TECHNICAL EVALUATION REPORT

MASONRY WALL DESIGN

OCONEE NUCLEAR STATION UNITS 1, 2, AND 3

NRC DOCKET NO. 50-269, 50-270, 50-287

SCHMATIC REPRESENTATION OF WALL MODIFICATIONS

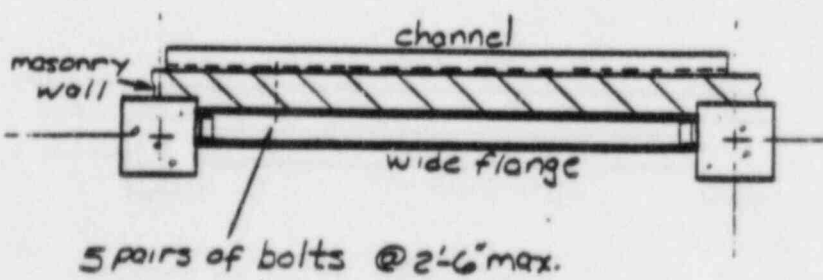
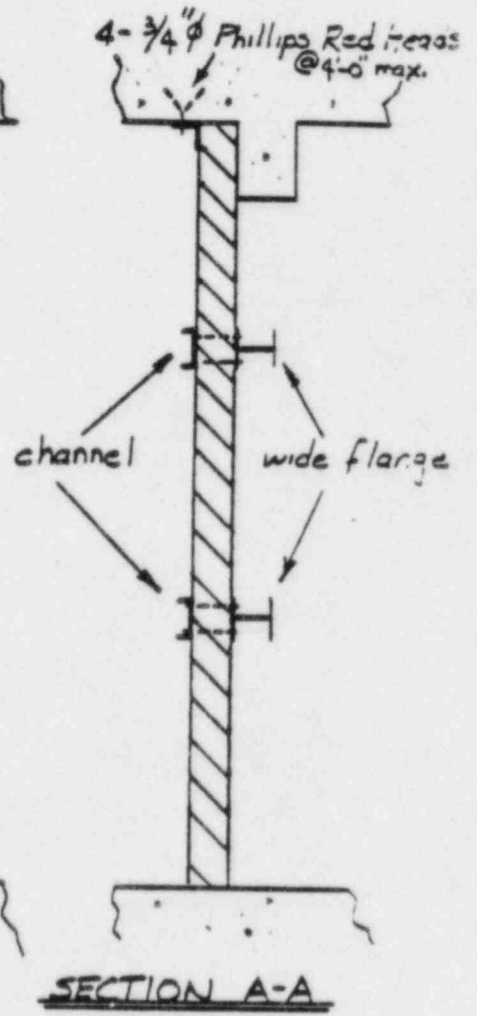
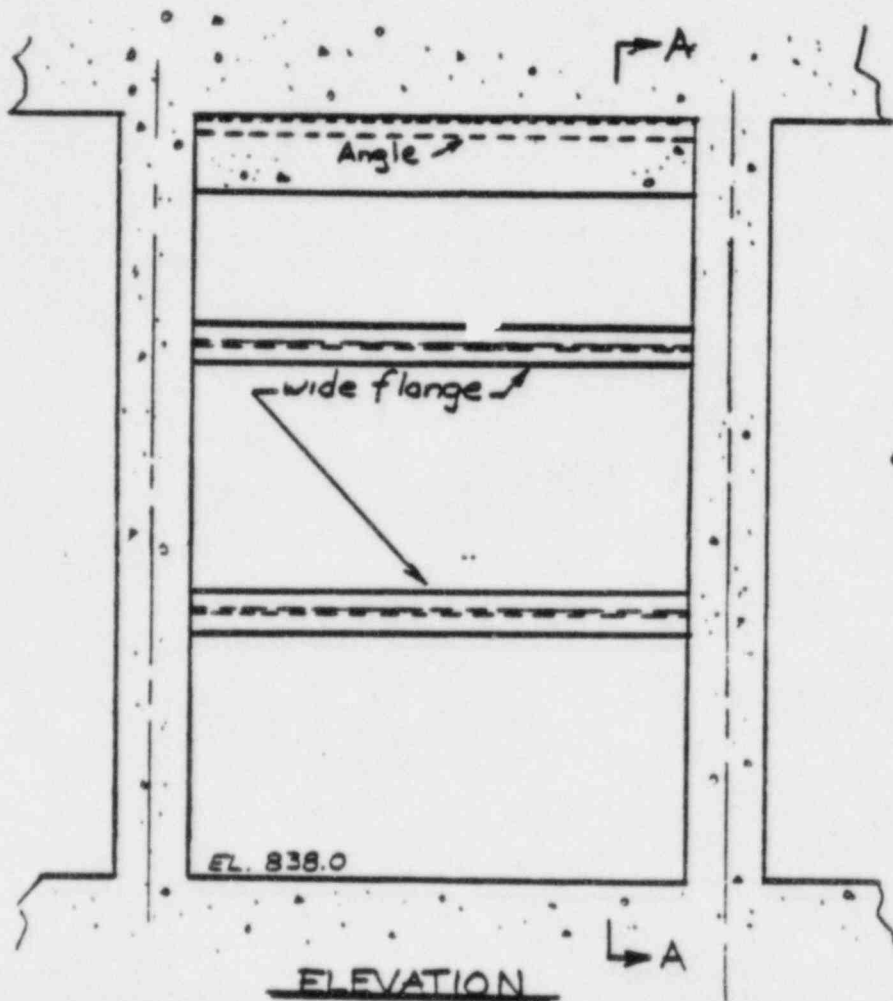
Provide details of proposed wall modifications with sample drawings and explain, using sample calculations, how these modifications will rectify the wall deficiencies. Also, provide a status report for the proposed wall modifications.

The Licensee's response indicated that the modifications have been instituted to provide an added margin of safety for several of the walls that are generally taller than normal and/or experience greater seismic acceleration and that there are no modifications to bring the walls' responses within the Licensee's acceptance criteria.

The Licensee has provided a typical modification in which steel beams have been placed horizontally to reduce the vertical span and hence reduce the bending moment of the wall. (See Appendix D for a schematic representation of wall modification.)

Since no actual modification was needed to bring the wall within the design allowable, it is concluded that the concern has been resolved satisfactorily.
